URBAN DESIGN COMMITTEE

URBAN DESIGN COMMITTEE STAFF REPORT

APPLICATION NUMBER	Urban Design Record #24052
APPLICATION TYPE	Advisory Review and Final Action
ADDRESS/LOCATION	NW Corner 26 th and U Streets
HEARING DATE	May 07, 2024
ADDITIONAL MEETINGS	--
APPLICANT	Aaron Burd, amburd76@gmail.com
STAFF CONTACT	Arvind Gopalakrishnan, 402-441-6361, agopalakrishnan@lincoln.ne.gov

APPLICATION NUMBER	Urban Design Record #24061
APPLICATION TYPE	Advisory Review and Final Action
ADDRESS/LOCATION	2100 N 1 st St, (SE corner of N 1 st Street and Cornhusker Hwy)
HEARING DATE	May 07, 2024
ADDITIONAL MEETINGS	--
APPLICANT	Sandra Washington, swashington@lincoln.ne.gov
STAFF CONTACT	Arvind Gopalakrishnan, 402-441-6361, agopalakrishnan@lincoln.ne.gov

Option A is a blend of board and batten siding with traditional lap siding.

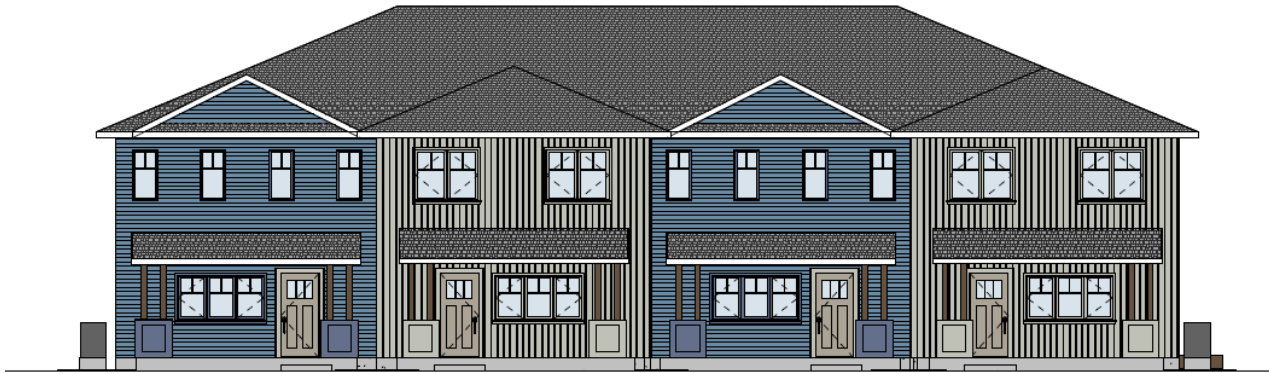
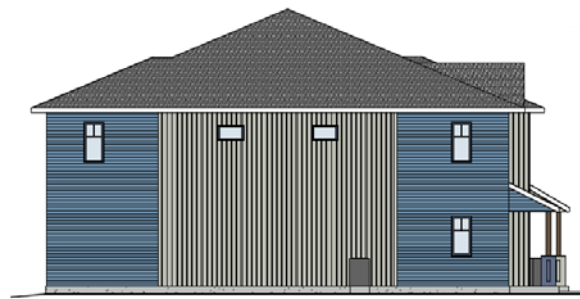
Both design options display craftsman-style doors, casement windows with false grills, and 6x6 columns on 32” tall, boxed bases, and porches separated by landscaping. The two bases at the center would screen the AC units.

The design for the Hawley Corners project on 645 N 26th Street- just south of U Street that was approved in 2022 by the HPC incorporated a combination of fiber-cement lap siding and board and batten siding. Hence, Staff recommends approval and suggests option A with board and batten siding as it enhances the facade by introducing greater variation and accentuating its visual appeal and would blend well within the neighborhood context.

North Elevation

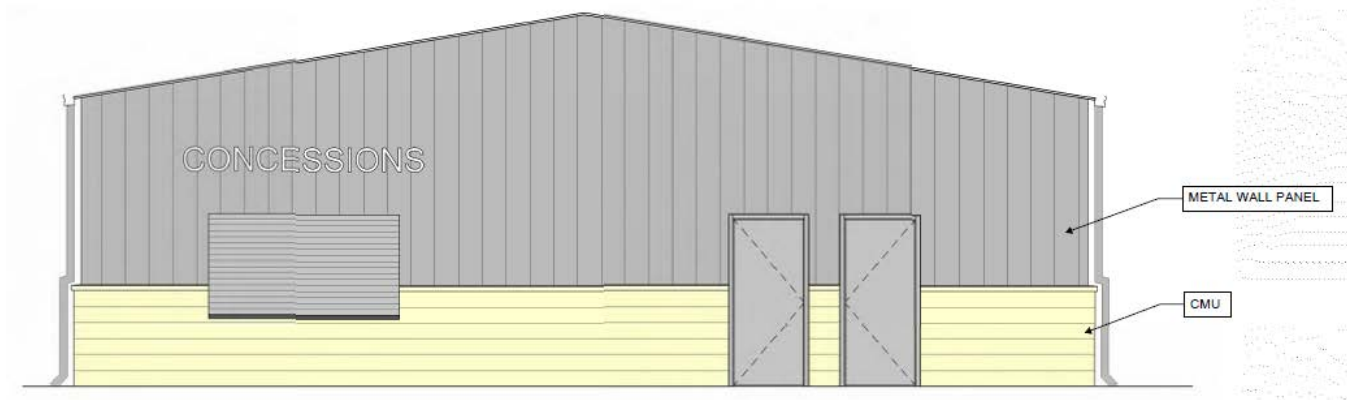
The concession and maintenance buildings are engineered metal buildings, with exterior color paneling and natural stone banding along the lower building elevations. The site color palette is a natural stone of light brown and darker brown on the metal panels. The championship dugouts will be a complimentary color tone of split-face masonry units and standing seam metal roofs.
